ENGINE - FUEL AND CONTROL - REPLACE THE FUEL PUMP PACKINGS WITH PACKINGS MADE FROM
IMPROVED MATERIAL - CATEGORY CODE 6 - MOD.ENG-73-0067

V2500-ENG-73-0067

NO. STS-73-001

ENGINE - FUEL AND CONTROL - REPLACEMENT OF LP/HP FUEL PUMPS FACE SEAL
ASSEMBLY AND O-RINGS

Figure 1
Input shaft sealing portion

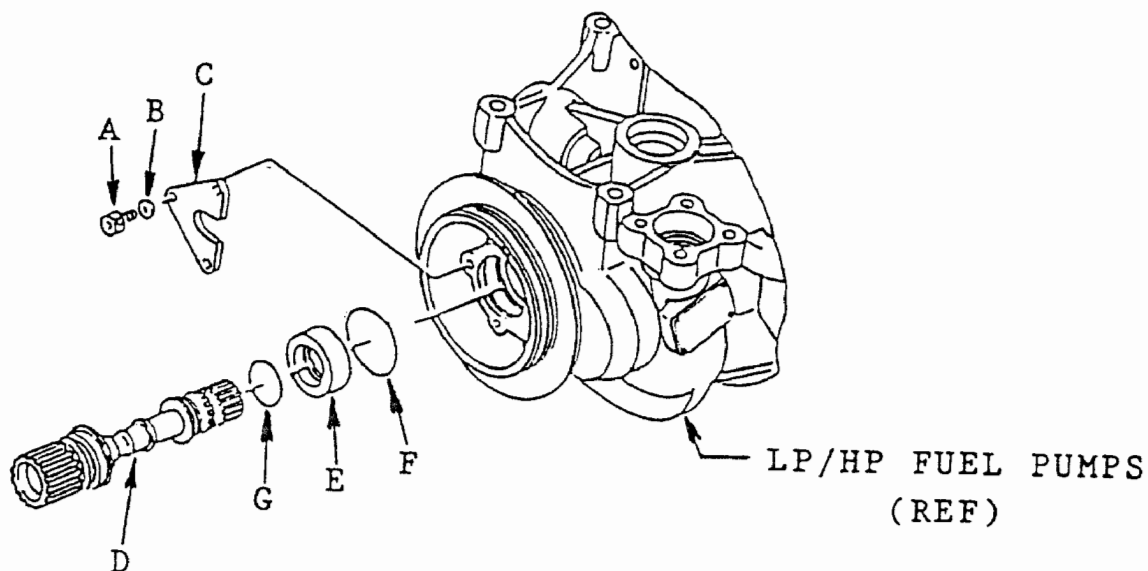
Disassemble the pump (refer to the Figure 1, Input shaft sealing portion of this Service Bulletin) in accordance with the following instructions to get the Face Seal Assembly (550, IPL Figure 1, 73-12-41; 570, IPL Figure 1, 73-18-41; 600, IPL Figure 1, 73-18-42) and O-Rings (50 and 560, IPL Figure 1, 73-12-41; 50 and 580, IPL Figure 1, 73-18-41; 50 and 610, IPL Figure 1, 73-18-42).

- (1) Remove the screws (A), washers (B), seal retaining plate (C), and input shaft (D) from the pump.
- (2) Remove the face seal assembly (E) and packing (F) from the pump.
- (3) Remove the packing (G) from the input shaft (D).
- (4) Discard the face seal assembly (E) and packings (F and G).

Replace the Face Seal Assembly (550, IPL Figure 1, 73-12-41; 570, IPL Figure 1, 73-18-41; 600, IPL Figure 1, 73-18-42) and O-Rings (50 and 560, IPL Figure 1, 73-12-41; 50 and 580, IPL Figure 1, 73-18-41; 50 and 610, IPL Figure 1, 73-18-42). Refer to the Figure 1, Input shaft sealing portion of this Service Bulletin.

Assemble the pump in accordance with the following instructions (refer to the Figure 1, Input shaft sealing portion of this service bulletin) with a new Face Seal Assembly and new O-Rings of Fluorocarbon.

- (1) Install the packing (F) and the face seal assembly (E) in the pump.

NOTE: Pay attention that carbon face of the face seal assembly (E) to be facing toward drive gear.

- (2) Install the packing (G) on the input shaft (D).
- (3) Install the input shaft (D) and the seal retaining plate (C). Attach with the screws (20) and washers (B). Torque screws to 51 to 56 in-lbs. (5.76 to 6.32 Newton metres).

NOTE: Apply a small amount of vaseline (commercially available), when the O-Rings are installed to the input shaft and pump.

Replace the currently required Face Seal Assembly and O-Rings with a new Face Seal Assembly part number (P/N 5910350) and new O-Rings (P/N M83248/1-116 and P/N M83248/1-130) as shown in the following.

A Fluorocarbon O-Ring which has less swell than Fluorosilicone does not take a compression set.
